Inspection report

Dogsthorpe junior Academy Central Ave Peterborough PE1 4LH	Date Of Inspection:18.3.25
Responsible Person: Vicky Redhead & John Wesson	Name Of Inspector(s): Billy Shaw
SENDCo: Faye Massingham	Relevant Contacts: Jo Bennett (H&S Contact), Edward Cymerlist (Site Manager)

250318 Accessibility Audit

Apr 2025 • DGA - Dogsthorpe Academy

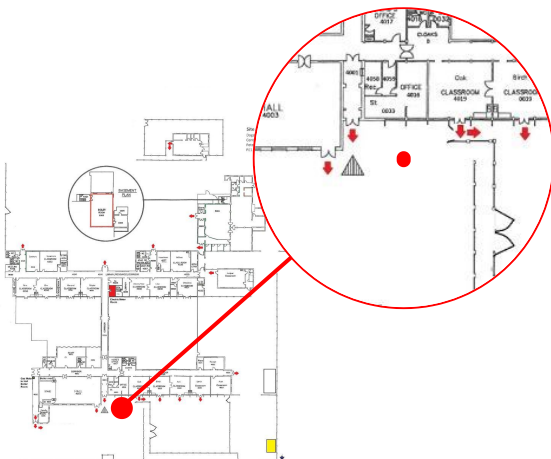
Entrance door access control at incorrect height.

Site the access control at suitable height between 750 - 1000mm above the floor. Ensure the control is visually apparent, operable with a closed fist and not cold to the touch and suitable for hearing impaired.

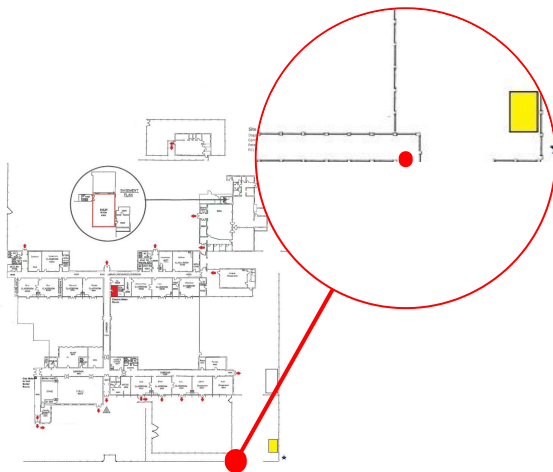
The academy gates are currently manual gates however these should be fitted with intercom and powered access where possible during future works

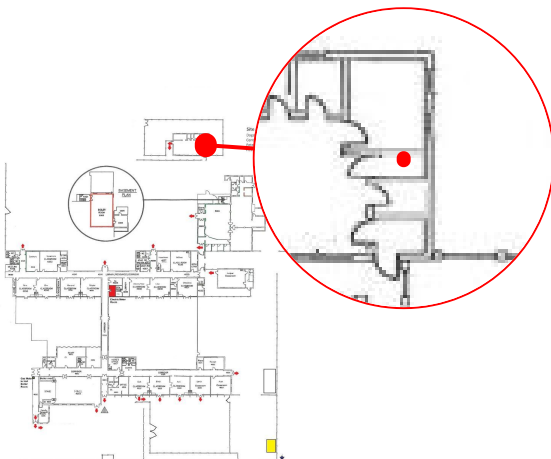
No fire alarm beacon present within accessible toilet.

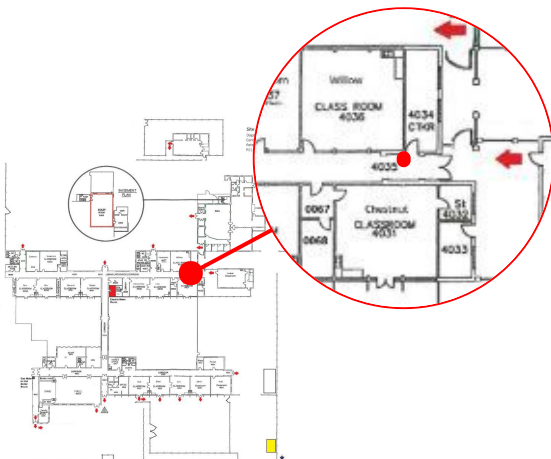
Only one accessible toilet in main building therefore travel distances would be exceeded from far end of building or user may be required to use accessible toilet in dining building.

All facilities at the far end of the build are available within the recommended travel distance from the accessible toilet within the main building, therefore any potential users may be located in an are within the academy allowing access to the required facilities.

The academy may need to consider installing an additional accessible toilet during future works where practical.

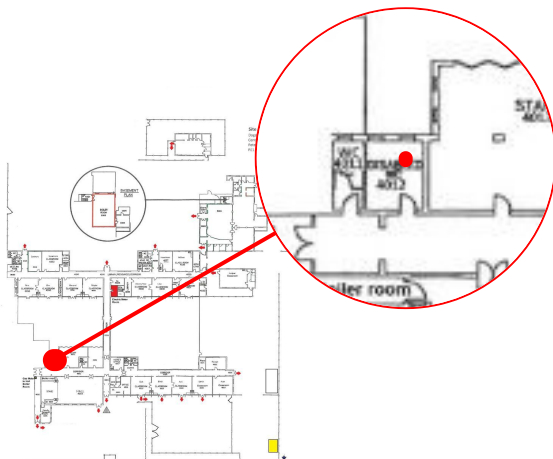
Emergency communication pull is not accessible.

Emergency communication pull should be within reach of the toilet, with a red triangle positioned at 100mm, and between 800mm - 1000mm from the floor.

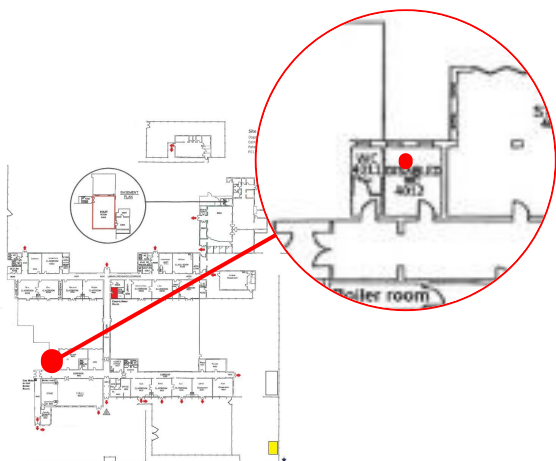
Emergency communication pull is not accessible.

Emergency communication pull should be within reach of the toilet, with a red triangle positioned at 100mm, and between 800mm - 1000mm from the floor.

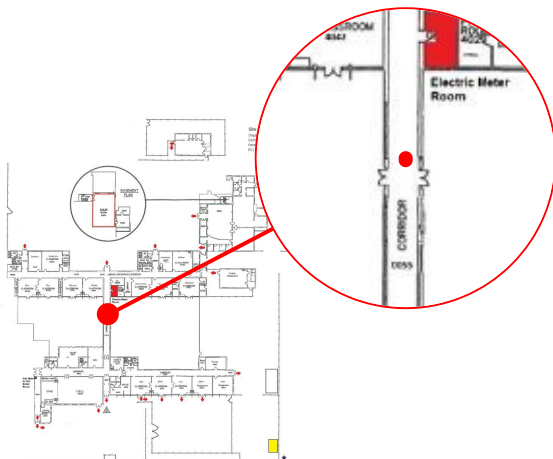
No Low Surface Temperature covers are present on older cast iron radiators.

Restrictor pins have been installed to prevent radiators reaching high temperatures however the academy should consider installing LST covers

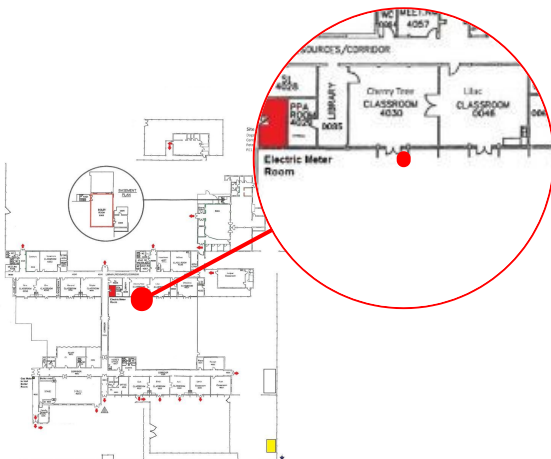
Edgings of steps faded.

Mark edges of steps/stairs with a slip resistant and contrasting nosing extending along the full width of the step to a depth of 50mm on tread and riser.

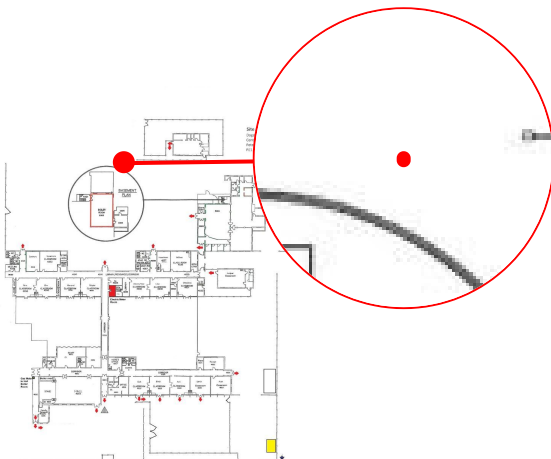
Handrail requires painting with a colour that is of sufficient contrast against surroundings

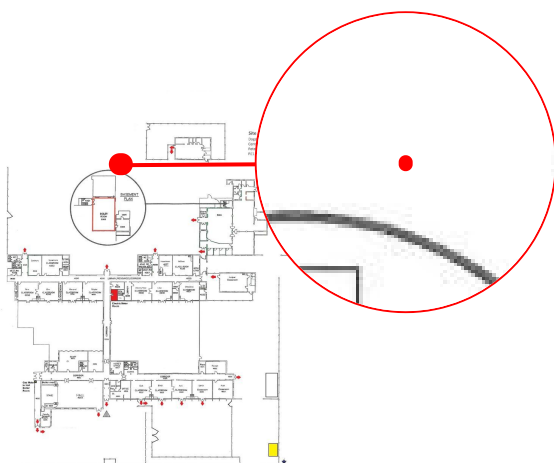
Edgings of steps/ stairs are damaged/ not marked.

Mark edges of steps/stairs with a slip resistant and contrasting nosing extending along the full width of the step to a depth of 50mm on tread and riser.

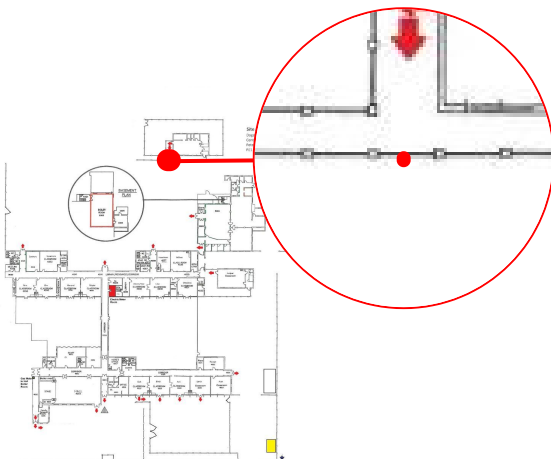
Edgings of steps/ stairs are damaged/ not marked.

Mark edges of steps/stairs with a slip resistant and contrasting nosing extending along the full width of the step to a depth of 50mm on tread and riser.

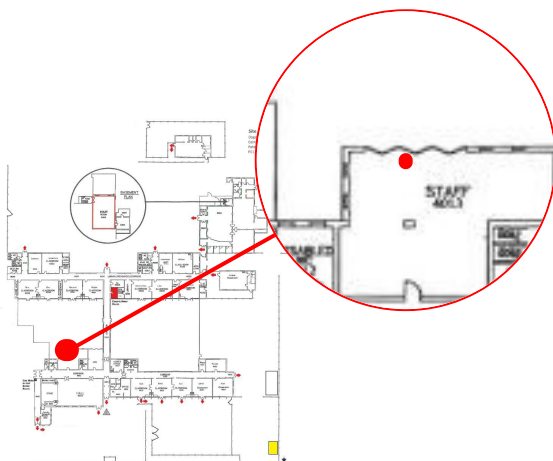
Manifestation markings not present on full length glass doors and windows

Install sufficient manifestation marking at 600mm - 800mm & 1200mm - 1400mm

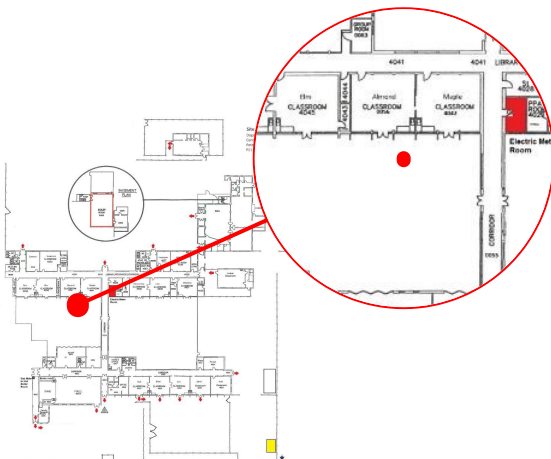
Highlighted changes in ground level have begun to wear.

Repaint to highlight changes in ground level, ensure that markings have sufficient contrast.

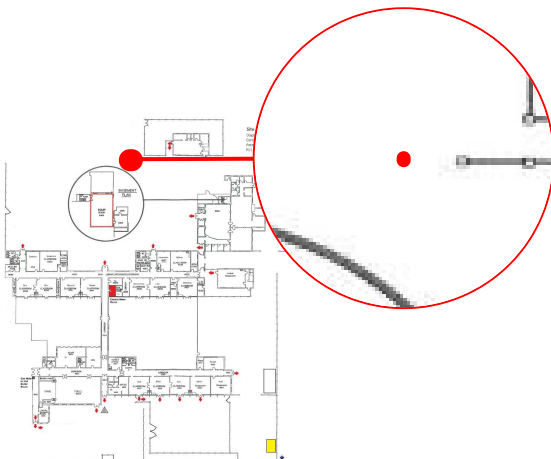
Soak away at the rear of playground presents trip hazard.

Install Markings to highlight changes in ground level, ensure that markings have sufficient contrast.
